PIC controller with v.1.4 firmware

For units with older firmware (or units purchased before 06/06/08). Upgrade your M2-ATX or M2-ATX-HV firmware by replacing the on-board PIC microcontroller.

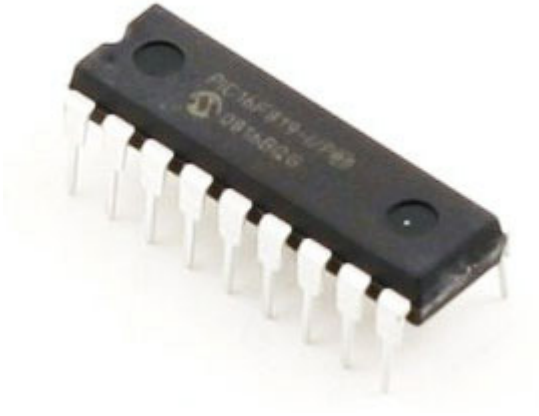
06/06/2008 Firmware 1.4: Shut down while ACPI is not fully up fix via 60 second AutoLatch feature

06/06/2008 Firmware 1.4: Officially introduced 3 more timing schemes: 0001 10 minutes / 1 hour 1001 15 minutes / 2 hours 0101 1 hour / 1 hour 15 minutes

06/06/2008 Firmware 1.4: In P0 (dumb PSU mode) if ignition is used, can act as an UPS system. (consult M2-ATX product page for more information)

- 1) Remove power from M2-ATX
- 2) Remove existent chip using a flat screwdriver.
- 3) Insert new chip.
